3/31/09	Added General Note (F)
DATE	REVISION	
STATE OF HAWAII DEPARTMENT OF TRANSPORTATION HIGHWAYS DIVISION BRIDGE GENERAL NOTES INTERSTATE ROUTE H-1 EXTENSION AND REPAIR OF SCHOOL STREET ON-RAMP RETAINING WALL Project No. H11-01-08 Scale: As Noted Date: Feb., 2009

3/31/09	Revised and/or Added Callouts and Legend
DATE	REVISION
STATE OF HAWAII DEPARTMENT OF TRANSPORTATION HIGHWAYS DIVISION RETAINING WALL REPAIR and EXTENSION EXISTING SITE PLAN INTERSTATE ROUTE H-1 EXTENSION and REPAIR of SCHOOL STREET ON-RAMP RETAINING WALL Project No. H11-01-08	
Scale: As Noted	Date: Feb, 2009
SHEET No. Q3 OF 34 SHEETS

RETAINING WALL REPAIR and EXTENSION

**WALL "I" DETAILS
WALL "M" and "N" SIMILAR**

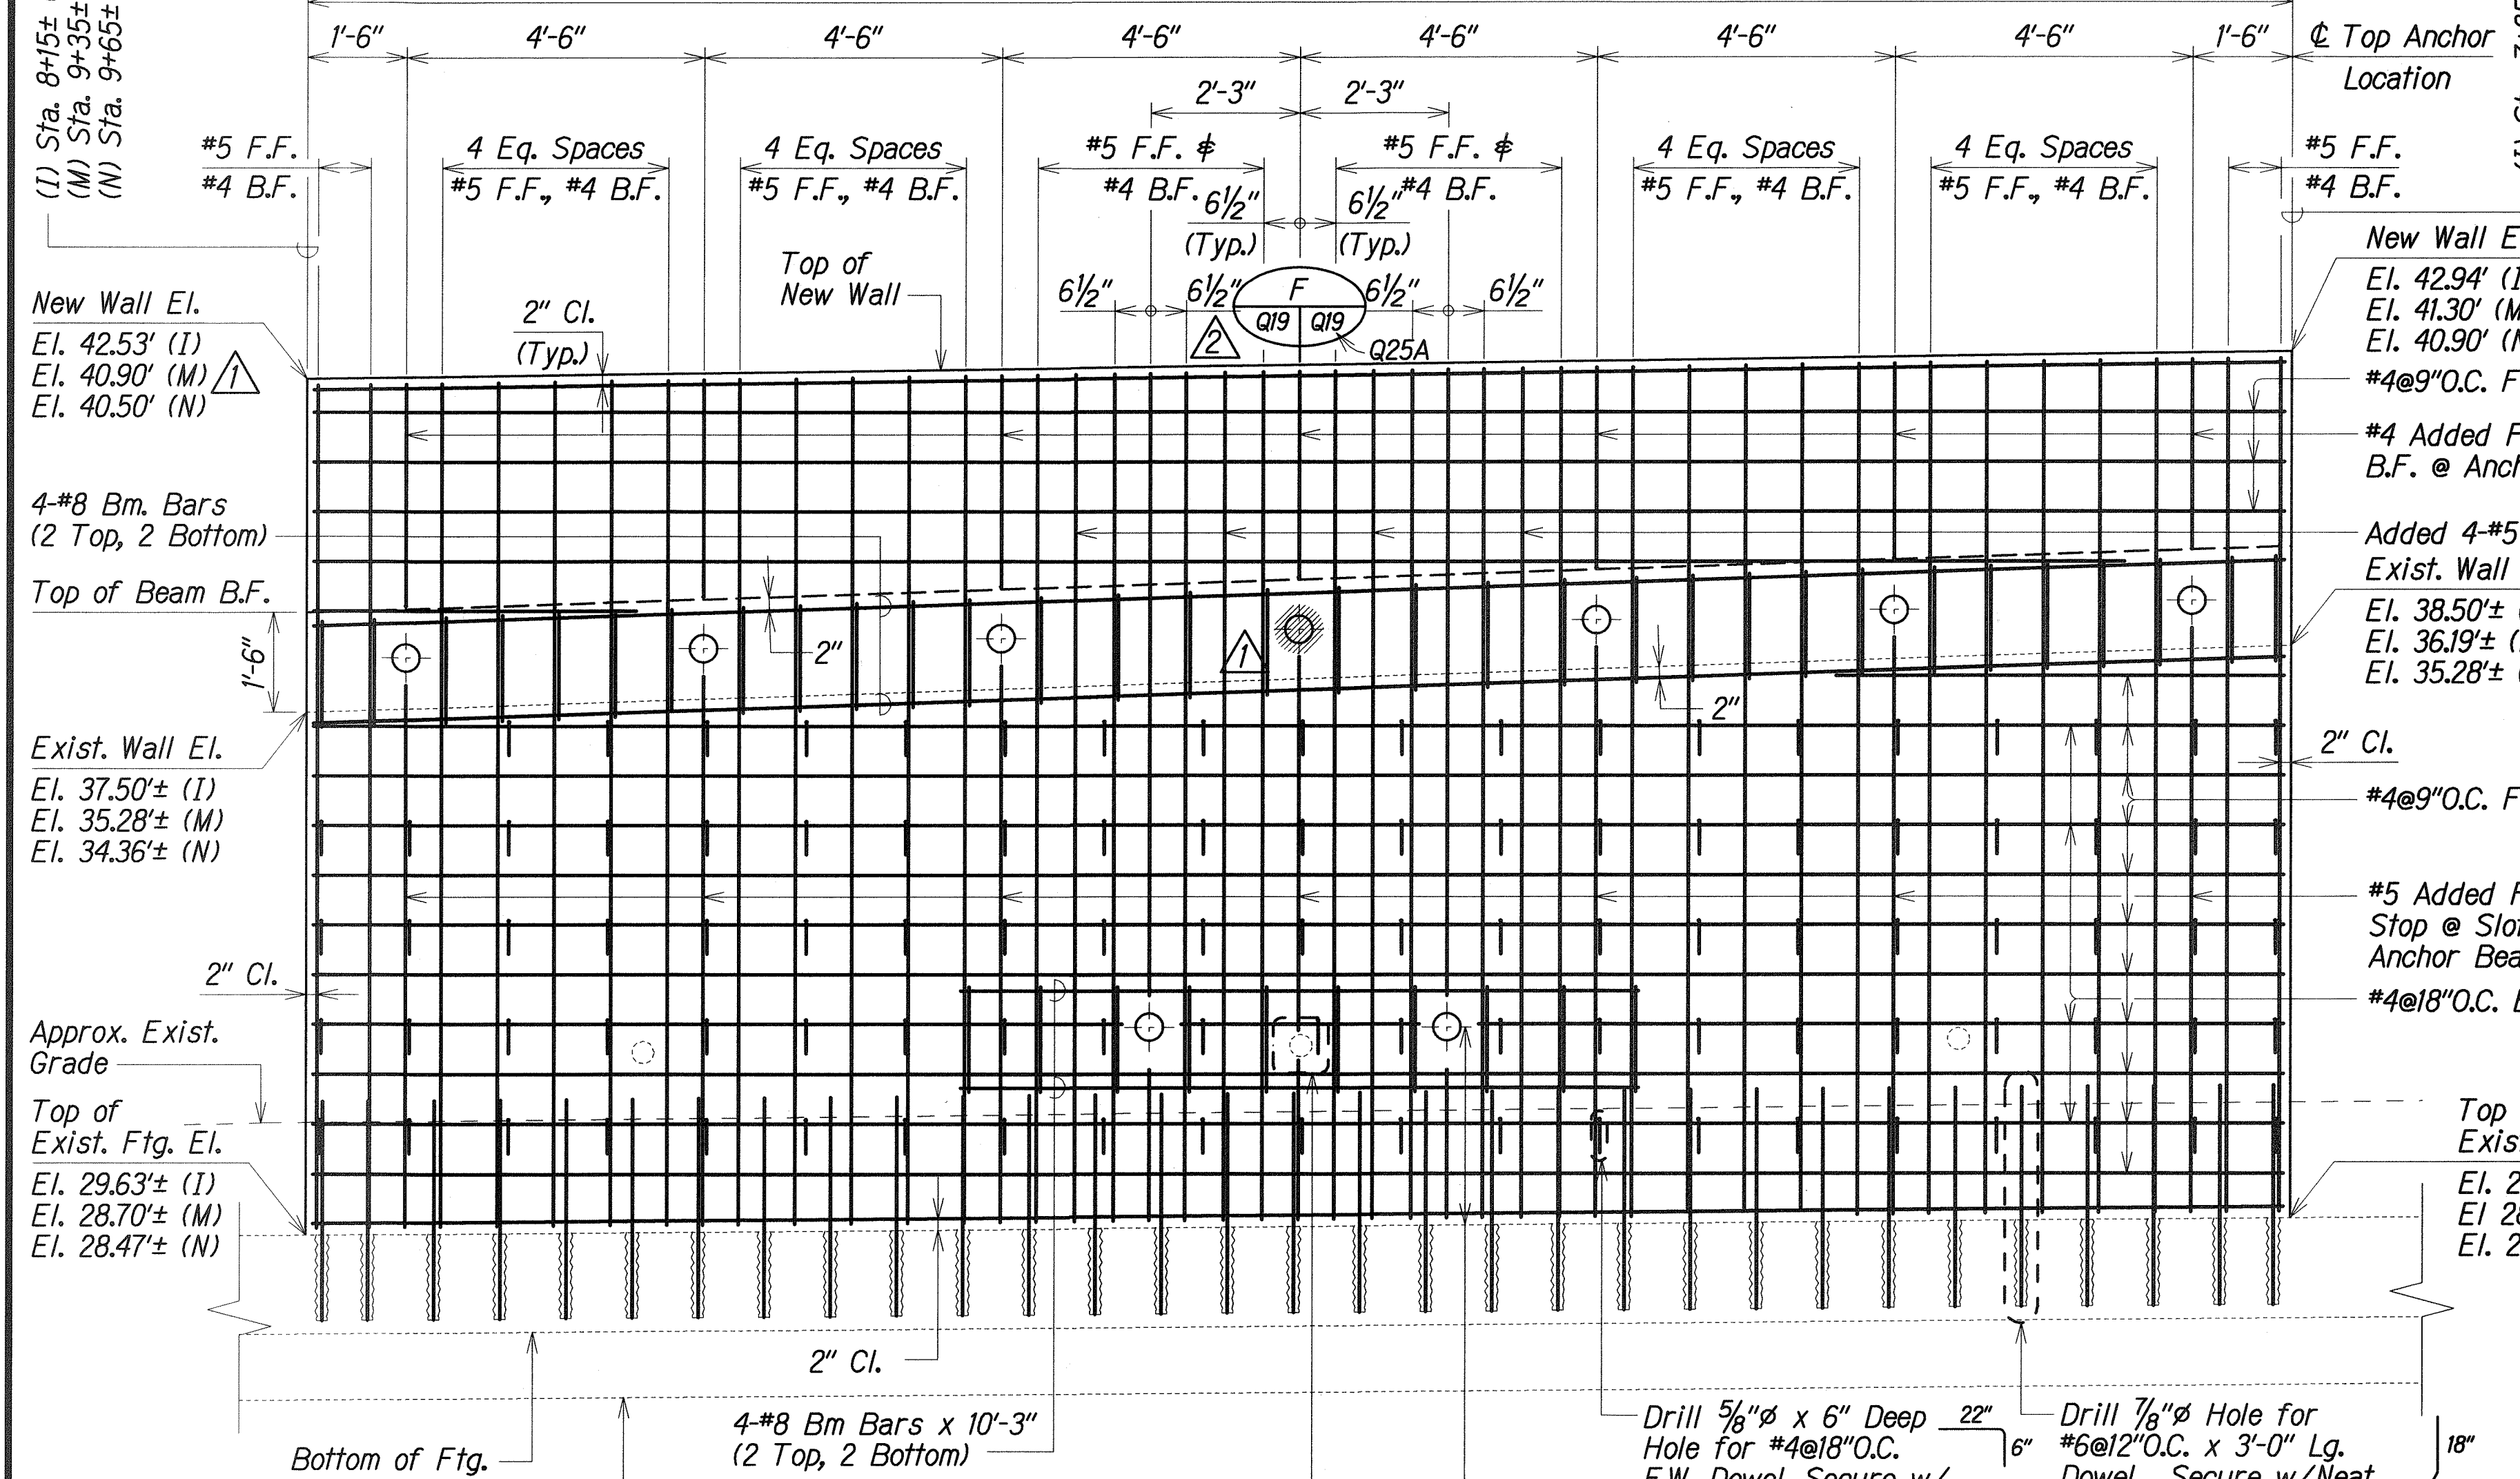
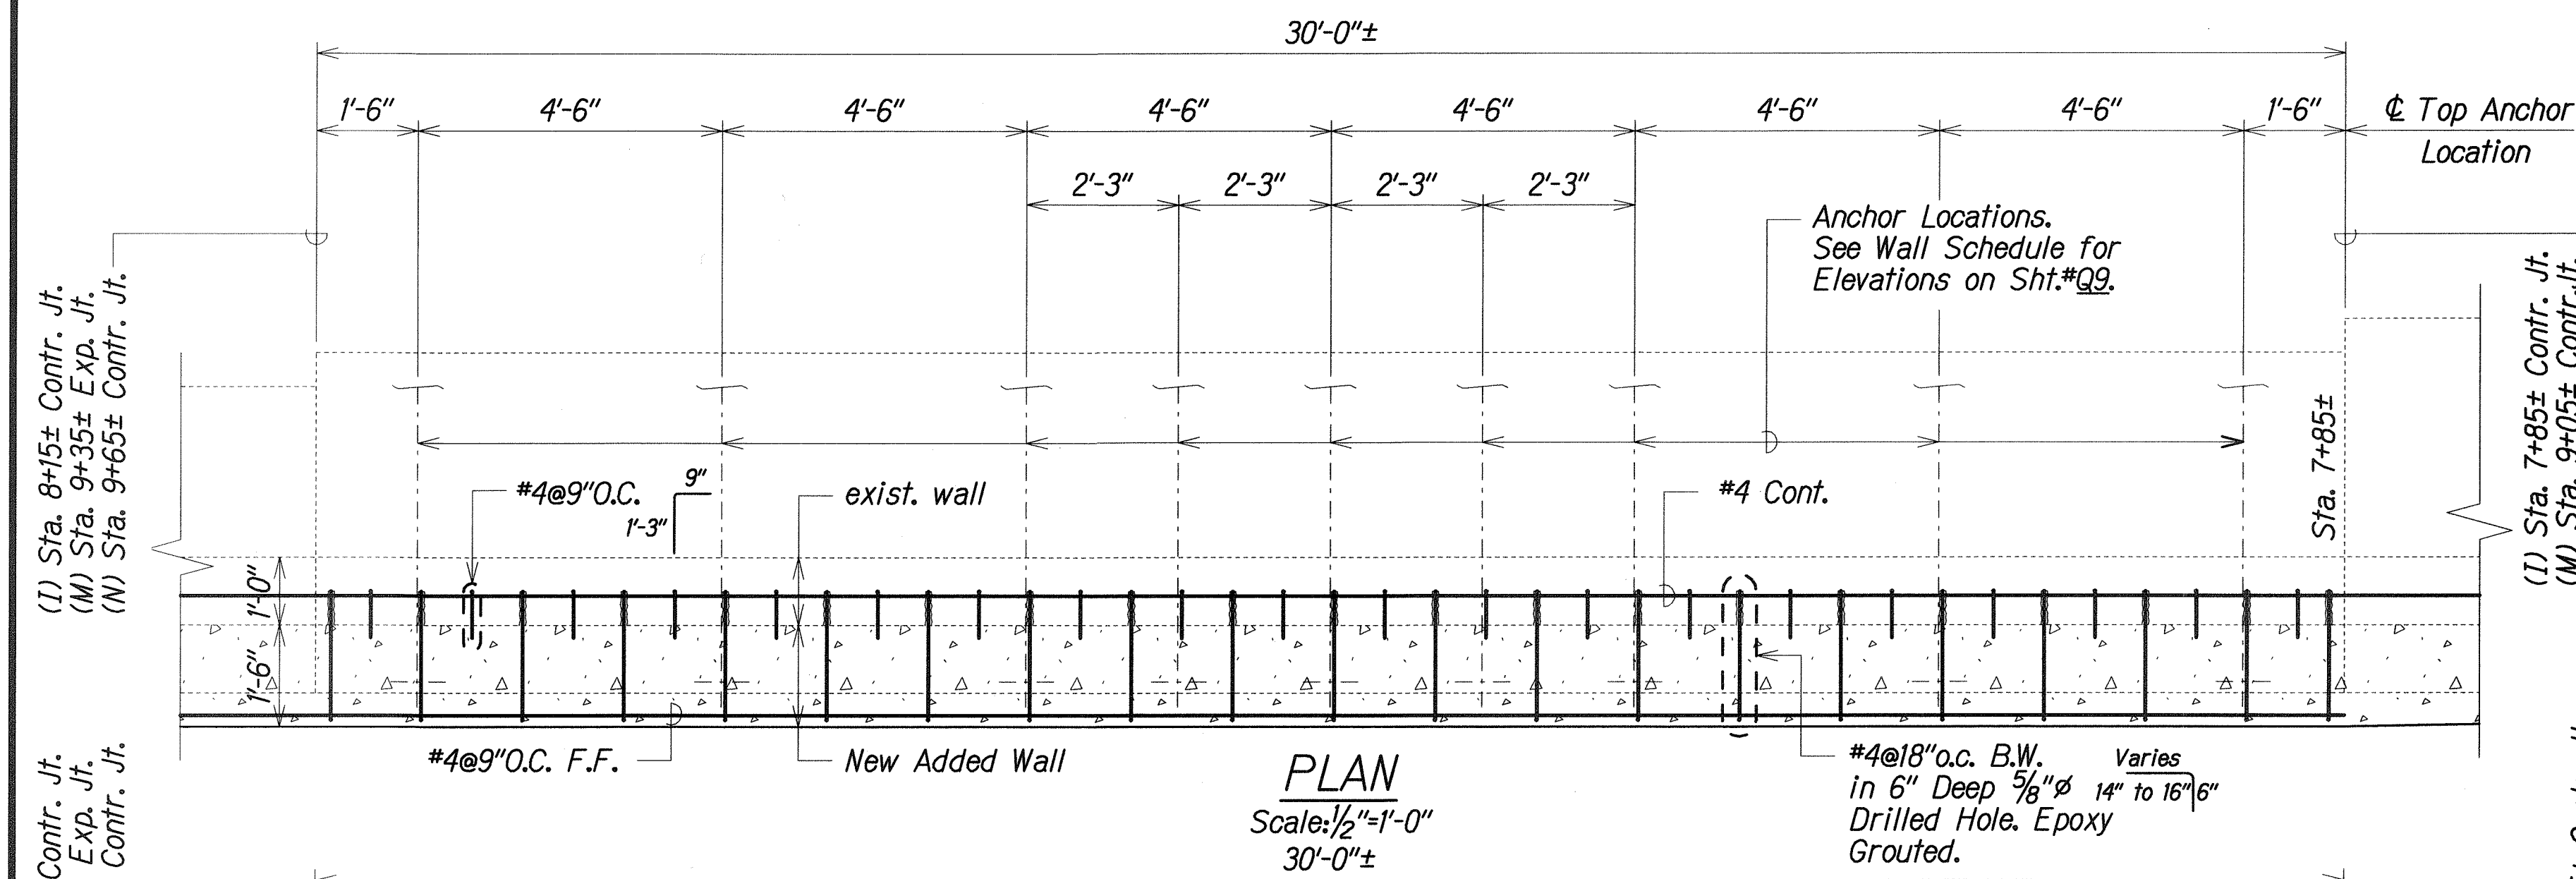
DATE	REVISION
8/17/09	Added Note No. 4, for Wall "M" Only and Added Sheet Number to Detail Symbol
3/31/09	Revised New Wall Elevations (M) & (N), Revised Detail Designation and Hatched Proof Test Anchor

- NOTES:**
1. $\angle$ of All Lower Anchors from Horizontal Shall be 20°.
 2. For Slot-Out Details, See Sheets Q25 & Q26.
 3. For Expansion & Contraction Joint Details, See Sht.*Q7.
 4. Additional Reinf. @ Wall "M" Only, See Sht.*Q25A.
